Access Compliance Report

Public Rights-of-Way

(Curb Ramps)

Intersection ID: 20720	Main Street: COVEDALE_DR	Cross Street: SARDIS_COVE_DR	Location: W
ADA ID: C710C1841BB9	Ramp Type: PerpDiag	Initial Pass/Fail: Fail	Overall Compliance: No
		Severity Score: 25

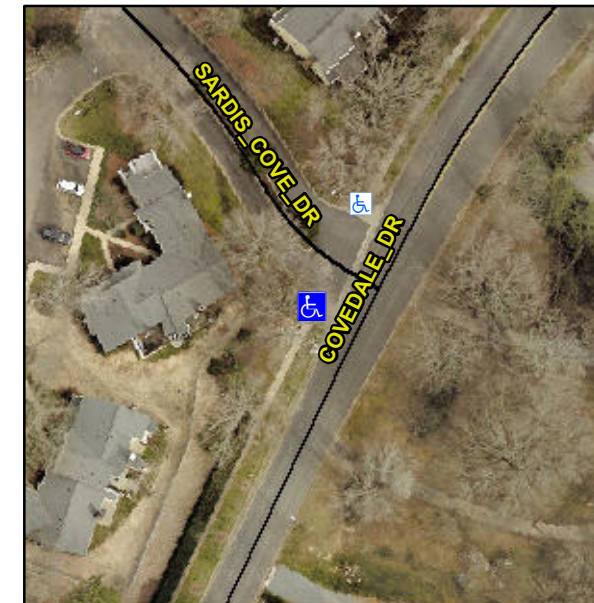
R304.2.2

Compliance	Description	Data	Compliance	Description	Data
N/A	Ramp Length (in)	91.0	No	Ramp Slope (%)	20.0
Yes	Ramp Width (in)	48.0	Yes	Ramp XSlope (%)	1.3
N/A	Flare Type LT	N/A	N/A	Flare Type RT	N/A
N/A	Flare Slope LT (%)	N/A	N/A	Flare Slope RT (%)	N/A
N/A	Flare Traversable LT?	N/A	N/A	Flare Traversable RT?	N/A
N/A	Landing Length (in)	N/A	N/A	DWS Provided?	N/A
N/A	Landing Width (in)	N/A	N/A	DWS Contrast?	N/A
N/A	Landing Slope (%)	N/A	N/A	DWS Length (in)	N/A
N/A	Landing X Slope (%)	N/A	N/A	DWS Full Width?	N/A
N/A	Landing Curb? (Y/N)	N/A	N/A	DWS Offset (in)	N/A
N/A	Shared Landing?	N/A			
N/A	Gutter Ponding?	N/A	N/A	Gutter Slope (%)	N/A
N/A	Gutter Lip Ht (in)	N/A	N/A	Gutter X Slope (%)	N/A
N/A	Painted X Walk1?	No	N/A	Painted X Walk2?	No
	X Walk 1 Direction	To SE		X Walk 2 Direction	To NE
N/A	X Walk 1 Width (in)	N/A	N/A	X Walk 2 Width (in)	N/A
	X Walk 1 Slope (%)	3.4		X Walk 2 Slope (%)	3.8
	X Walk 1 X Slope (%)	1.3		X Walk 2 X Slope (%)	6.8

Remove & Replace Curb Ramp With Two New Directional Ramps or Equivalent.
